## PRODUCT CHANGE NOTIFICATION (PCN)

### A-MCSP-80005/B MODULAR CABLE

CHANGE NOTIFICATION: PCN 20220425\_A-MCSP-80005/B

DESCRIPTION OF CHANGES: CHANGE OF DATA SHEET  
CHANGE OF DATA SHEET  
New Draw.-No. ASS\_7425\_CArev07

ASSMANN WSW-No. <b>A-MCSP-80XXX/X</b>	
Drawing-No. <b>ASS 7425 CA</b>	rev07
Replace	Sheet

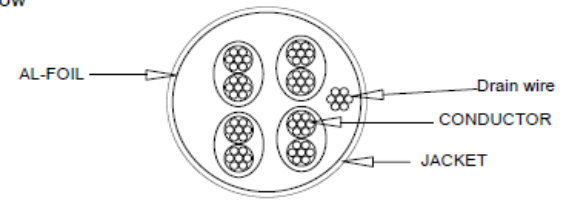
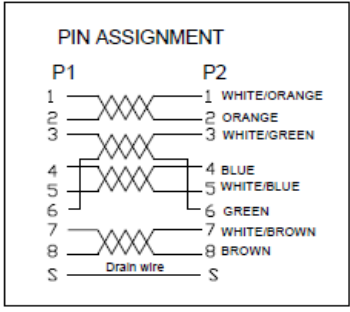
REASON FOR CHANGE: CHANGE OF PRODUCT LOCATION  
CHANGE OF PRODUCT LOCATION

A-MCSP-80005/B	OLD VERSION	A-MCSP-80005/B	NEW VERSION																																																	
<p>Appearance</p>		<p>Appearance</p>																																																		
<p>BOM</p> <table border="1"> <thead> <tr> <th>NO</th> <th>PART NO</th> <th>DESCRIPTION</th> <th>QTY</th> <th>UNIT</th> </tr> </thead> <tbody> <tr> <td>3</td> <td>mold</td> <td>PVC,50P</td> <td>9.0</td> <td>G</td> </tr> <tr> <td>2</td> <td>plug</td> <td>8P8C plating gold 3U* with metal shield</td> <td>2</td> <td>PCS</td> </tr> <tr> <td>⑤ 1</td> <td>cable</td> <td>FTP (26AWG*1P)*4+D+A+PVC, OD:5.2±0.2mm CAT5E</td> <td>2.0</td> <td>M</td> </tr> </tbody> </table>		NO	PART NO	DESCRIPTION	QTY	UNIT	3	mold	PVC,50P	9.0	G	2	plug	8P8C plating gold 3U* with metal shield	2	PCS	⑤ 1	cable	FTP (26AWG*1P)*4+D+A+PVC, OD:5.2±0.2mm CAT5E	2.0	M	<p>BOM</p> <table border="1"> <thead> <tr> <th>NO</th> <th>PART NO</th> <th>DESCRIPTION</th> <th>QTY</th> <th>UNIT</th> </tr> </thead> <tbody> <tr> <td>⑦</td> <td>△</td> <td>AL-Foil</td> <td>Double-sided conductive aluminum foil</td> <td>2</td> <td>PCS</td> </tr> <tr> <td>⑦</td> <td>△</td> <td>mold</td> <td>PVC,65P</td> <td>AR</td> <td>G</td> </tr> <tr> <td></td> <td>△</td> <td>plug</td> <td>8P8C plating gold 3U* with metal shield</td> <td>2</td> <td>PCS</td> </tr> <tr> <td>⑦⑤</td> <td>△</td> <td>cable</td> <td>CAT5E F/UTP (26AWG*1P)*4+D+A+PVC, OD:5.2±0.2mm</td> <td>AR</td> <td>M</td> </tr> </tbody> </table>		NO	PART NO	DESCRIPTION	QTY	UNIT	⑦	△	AL-Foil	Double-sided conductive aluminum foil	2	PCS	⑦	△	mold	PVC,65P	AR	G		△	plug	8P8C plating gold 3U* with metal shield	2	PCS	⑦⑤	△	cable	CAT5E F/UTP (26AWG*1P)*4+D+A+PVC, OD:5.2±0.2mm	AR	M

NO	PART NO	DESCRIPTION	QTY	UNIT																																																
3	mold	PVC,50P	9.0	G																																																
2	plug	8P8C plating gold 3U* with metal shield	2	PCS																																																
⑤ 1	cable	FTP (26AWG*1P)*4+D+A+PVC, OD:5.2±0.2mm CAT5E	2.0	M																																																
NO	PART NO	DESCRIPTION	QTY	UNIT																																																
⑦	△	AL-Foil	Double-sided conductive aluminum foil	2	PCS																																															
⑦	△	mold	PVC,65P	AR	G																																															
	△	plug	8P8C plating gold 3U* with metal shield	2	PCS																																															
⑦⑤	△	cable	CAT5E F/UTP (26AWG*1P)*4+D+A+PVC, OD:5.2±0.2mm	AR	M																																															
<p>FOR DETAIL, PLEASE TAKE ATTACHED NEW DRAWING: FOR REFERENCE</p>

⑦	△	AL-Foil	Double-sided conductive aluminum foil	2	PCS
⑦	△	mold	PVC,65P	AR	G
	△	plug	8P8C plating gold 3U* with metal shield	2	PCS
⑦⑤	△	cable	CAT5E F/UTP (26AWG*1P)*4+D+A+PVC, OD:5.2±0.2mm	AR	M
NO	PART NO	DESCRIPTION		QTY	UNIT

Scale	FREE	⑦	Change the plant	12.04.2022	Luca	Date	Name	Customer-No.
TOLERANCE		⑥	Clarify the tolerance	23.08.2018	Segal	Drawn	26.06.2015	Joanna
X.	±X	⑤	Add "CAT5E"	20.10.2017	Stephon	Approved	12.04.2022	Luca
X.X	±X	④	Add length for 20M and 30M	20.09.2017	Fred			
X.XX	±X	③	remove mark on the mould	29.06.2016	Joanna			
DIM	TOL	②	Add length for 300mm	18.05.2015	Joanna			
ANGLE	±X°							
Angle	TOL	Id.	Modification	Date	Name
